ZONING BOARD OF ADJUSTMENTS PUBLIC HEARING

CITY OF FAIR OAKS RANCH, TEXAS

AGENDA TOPIC: The Zoning Board of Adjustment of the City of Fair Oaks Ranch, Texas, will conduct a public hearing to receive public testimony on the Variance Application No. ZBOA 2022-06-22 from Damon Gray of D & A Gray Enterprises LLC, applicant and property owner, to grant variances for the property located at 29105 Noll Road, Fair Oaks Ranch, TX, also listed as 29105 Noll Road, Boerne, TX in the Bexar County Property Records.

Illustration 1: Applicant's Proposal

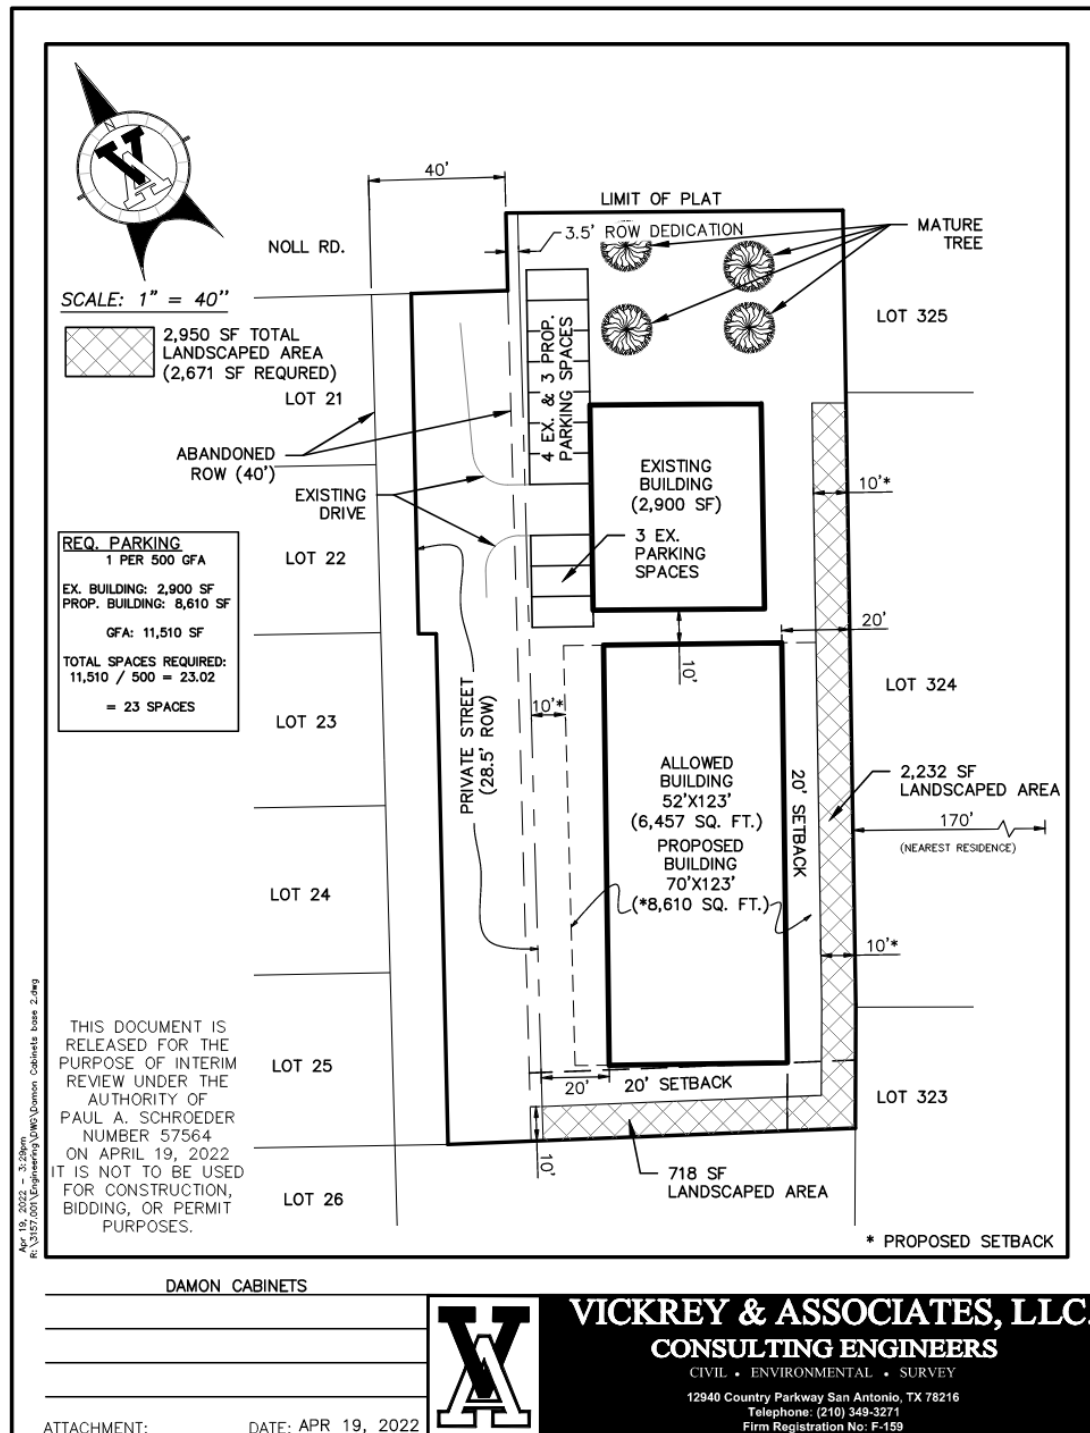
1. Access to the parking spaces: The applicant proposes to have all parking spaces perpendicular and immediately adjacent to the street. This direct access from the street is not permitted and can cause accidents from vehicles reversing onto the street. The UDC requires parking spaces be accessed by an aisle or driveway from a road.
2. Number of parking spaces: The parking spaces on site will be less than the required number of spaces.
3. Screening of parking areas from the street: Parking spaces will not be screened from the street, as required.
4. The residential transition setback will be reduced from the 20' minimum requirement to

10'. Considering the commercial nature of the proposed use that will involve onsite fabrication and millwork, the use will have adverse impact on the neighboring residential uses.

5. The front setback will be reduced to 10' from the required 20' setback. Considering that the applicant is requesting variances from screening, landscaping, and parking variances, the reduction of the front setback will be detrimental.
6. Parking setback from the street: Parking spaces will not have a 3' wide setback from the street, as required.

1. Variance from Section 6.7 (4) c – Allow access to parking directly from the street instead of from an aisle or a driveway.

The proposed site development does not provide driveway or aisle access to parking. All parking spaces will have access directly from the street and will use the public street to reverse a vehicle.

2. Variance from Section 6.7, Table 6.2 – Reduce the number of parking spaces from 24 spaces to 10 spaces. The current required ratio is one space per 500 square feet of usable building area for the existing use. The facility expansion requires 24 parking spaces for the 11,510 square foot proposal while the applicant is proposing only 10 spaces. The applicant has not identified any constraints on the property that would prevent the applicant from meeting UDC requirements for parking.

3. Variance from the requirements of Section 6.8 (2) d – Eliminate the required 3' parking setback from the street.

4. Variance from the requirements of UDC Section 6.8 (2) b (i) - Allow reduction in the required

minimum front setback of 20 feet to 10 feet.

5. Variance from UDC Section 6.8 (2) (e) (iii) – Allow reduction in the required minimum residential transition setback of 20 feet to 10 feet.

6. Variance from Section 7.7 (1) – Eliminate the required 3' high landscaping screening strip between parking and street. If Variance No. 1 is approved to allow direct street access to the parking area, no landscaping strip can be installed. There is room for landscape screening, however, the existing site plan does not propose any screening.

Illustration 2: Schematic Diagram Showing Compliance

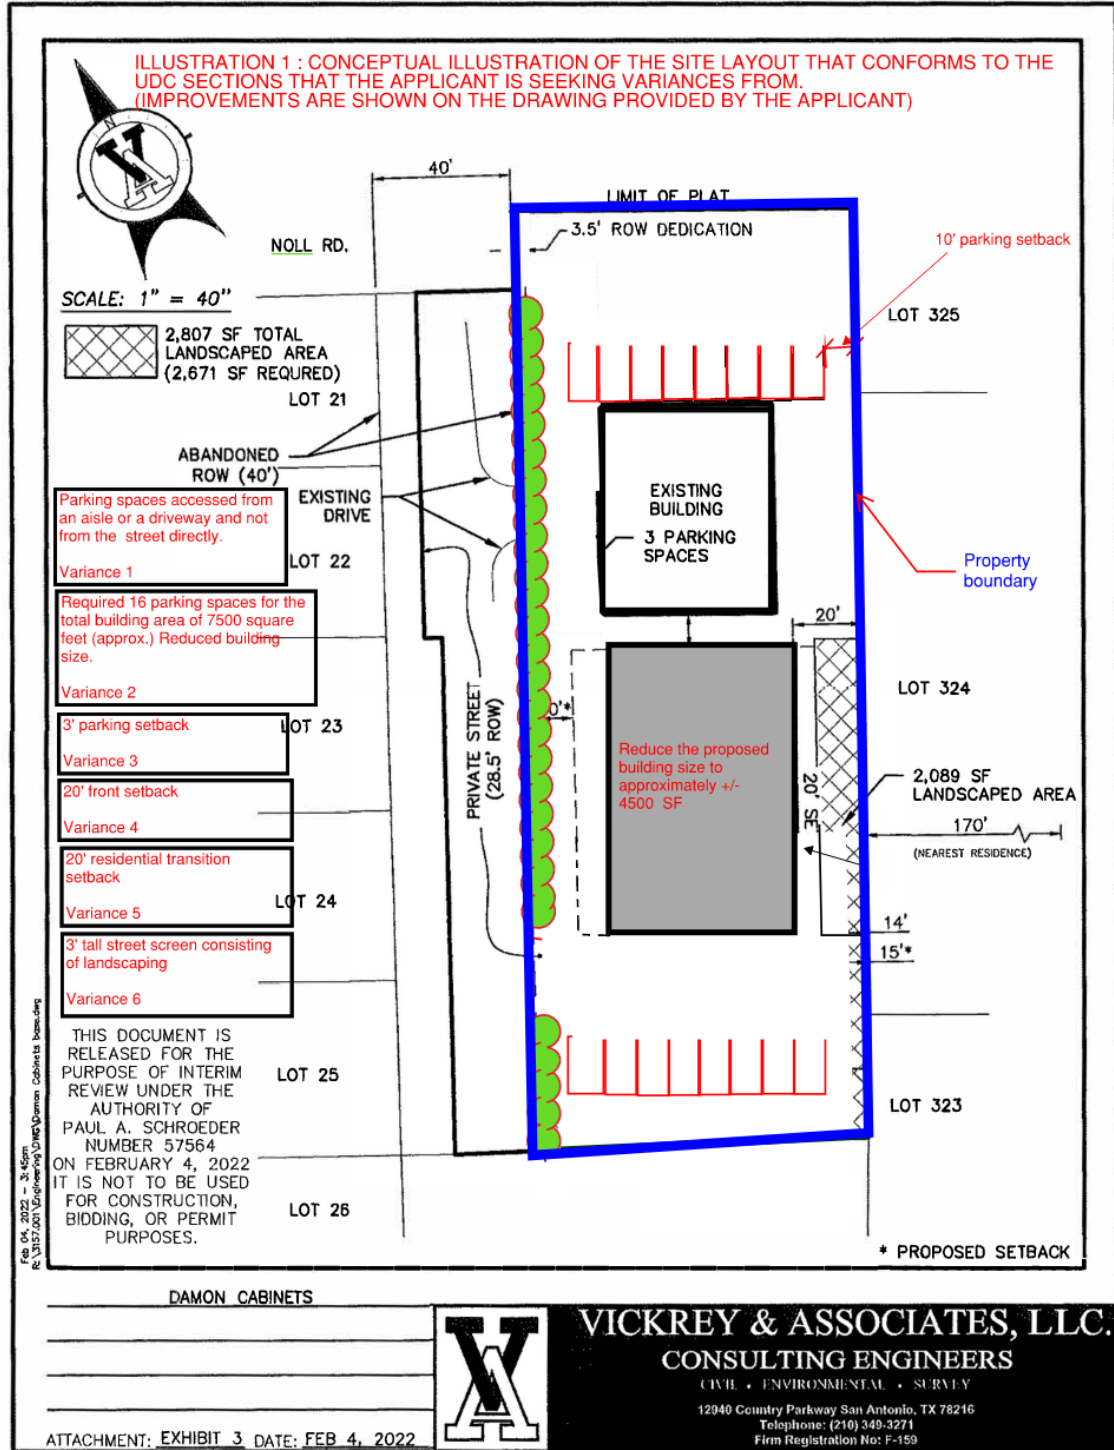
Finding: Per the Schematic Diagram below, it is staff's opinion that the site plan and parking layout can be designed to meet this requirement. The applicant has not identified any constraints on the property that would prevent the applicant from meeting UDC requirements for parking access. The criteria in UDC Sec. 3.9 (9), listed earlier in this report, do not apply and a deviation is not warranted. Adherence to this requirement will not prohibit or unreasonably restrict the utilization of the property.

Finding: It is staff's opinion that the site can be designed to meet this requirement by reducing the size of the new building which would require less parking spaces per the **Illustration 2: Schematic Diagram Showing Compliance** below. The criteria in UDC Section 3.9 (9), listed earlier in this report, do not apply and a deviation is not warranted. Adherence to this requirement will not prohibit or unreasonably restrict the utilization of the property.

Finding: It is staff's opinion that the site can be redesigned to accommodate the required parking setback per the **Illustration 2: Schematic Diagram Showing Compliance** below and therefore this Variance is not warranted. The criteria in UDC Sec. 3.9 (9), listed earlier in this report, do not apply and a deviation is not warranted. Adherence to this requirement will not prohibit or unreasonably restrict the utilization of the property.

Finding: It is staff's opinion that the site can be redesigned to accommodate the required front setback as shown in **Illustration 2: Schematic Diagram Showing Compliance** below (prepared by staff) and therefore this Variance is not warranted. The criteria in UDC Sec. 3.9 (9), listed earlier in this report, do not apply. Adherence to this requirement will not prohibit or unreasonably restrict the utilization of the property.

Finding: It is staff's opinion that the site can be redesigned to accommodate the required residential transition setback as shown in **Illustration 2: Schematic Diagram Showing Compliance** below (prepared by staff) and therefore this Variance is not warranted. The criteria in UDC Sec. 3.9 (9), listed earlier in this report, do not apply and a deviation is not warranted. Adherence to this requirement will not prohibit or unreasonably restrict the utilization of the property.

Finding: It is staff's opinion that the site can be designed to meet this requirement as shown in **Illustration 2: Schematic Diagram Showing Compliance** below (prepared by staff). The criteria in UDC Section 3.9 (9), listed earlier in this report, do not apply and a deviation is not warranted. Adherence to this requirement will not prohibit or unreasonably restrict the utilization of the property.

Review of the site indicates that the requirements of the UDC in terms of access, landscape screening, parking setback from the street, and number of parking spaces can be met by re-designing the layout per the **Illustration 2: Schematic Diagram Showing Compliance** below. In conclusion, it is staff's opinion that the requested Variances do not meet the criteria listed for findings of a hardship as per UDC Sec. 3.9 (9). The facility expansion can be redesigned with an appropriately-sized building to meet all the requirements of the UDC. The hardship appears to be self-created, is based solely on economic gain or loss, and will allow development of this parcel in a manner not permitted by the City's zoning regulations.
